Case # EH-PLANS-25-0
Type EnvHealth/Environmental Health/Plan Check/Application

Single Entry Edit-View Record Form
Application Name B25000414

Description SFD//REPLACE TWO EXISTING DECKS - FIRST TO BE 19X37 IRREGULAR SHAPE WITH STEPS AND THE OTHER TO BE 12X29 WITH NO STEPS**SUBJECT TO FIELD INSPECTION**

ON-SITE SEWAGE DISPOSAL SYSTEM HOWARD COUNTY HEALTH DEPARTMENT BUREAU OF ENVIRONMENTAL HEALTH

From: Eshenbaugh, Melanie
Sent: Friday, February 7, 2025 2:38 PM
To: michelle@appliedandapproved.com
Subject: B25000414
Attachments: 1000020517.jpg; 1000020518.jpg; 1000020520.jpg

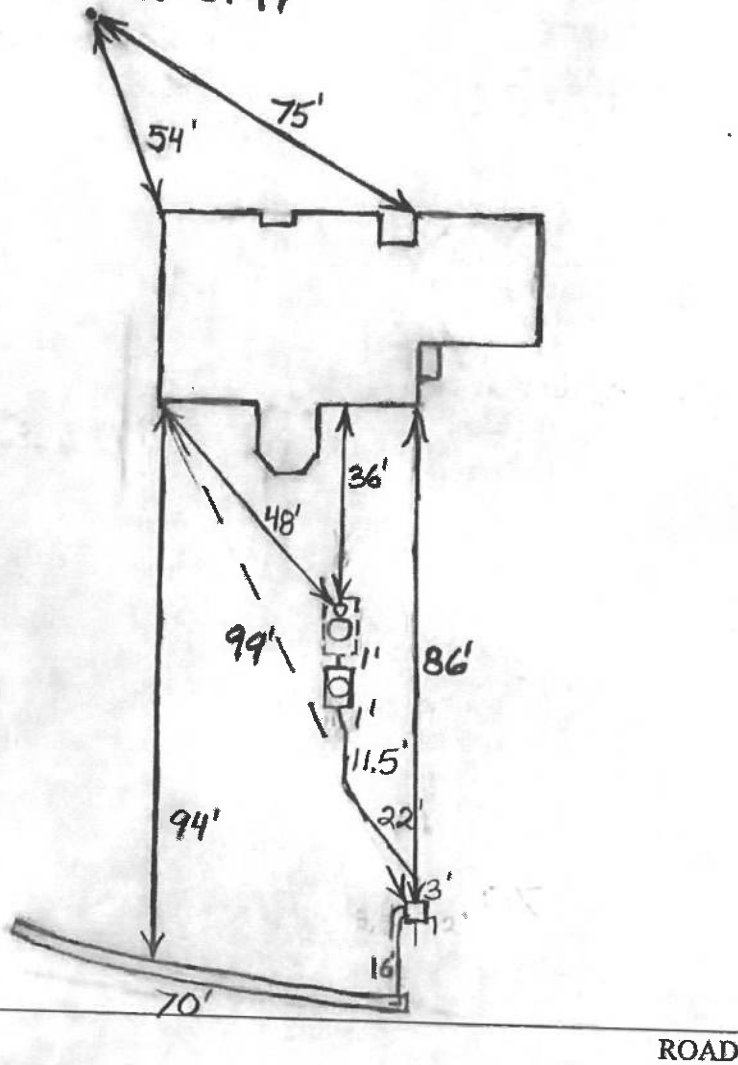
After review of the building permit request and conducting a site visit at this property, I noticed that the well condition is of concern. The conduit isn't secured under the well cap and there were a couple missing bolts which can present a groundwater contamination risk. Additionally, to gain approval of building permit #B25000414, we kindly request that the repair of the well conduit/cap to ensure that the well components are watertight. This requirement is in response to conducting the site visit to the property on 2/5 and observing the condition of the well cap/conduit (see attached photos). The well conduit will need to be secured under the cap and will need repaired to ensure water potability standards for the residence in accordance with Health Dept. code (code requirements in COMAR 26.04.04.25). Please submit to the Health Dept. office documentation of the well repair via email or mail as proof of completion of the work. Also, we strongly recommend water testing for bacteria to ensure there is no potential health risk to the occupants of the property. Please contact the Community Hygiene program (410-313-1773) and someone can assist with scheduling water sampling if there is a desire to have the well water tested. Let me know if you have any questions and thank you kindly.

Well cap replacement : Remove and replace well cap for new two piece sealed cap and conduit.

Service #	Description	Quantity	Your Price	Your Total
AB-S-WW- WELLCAP	Replace Existing Well Cap with New Sealed Well Cap Prevents bugs and other critters from entering the well casing with a seal around the casing and screened vents.	1.00	\$281.93	\$281.93
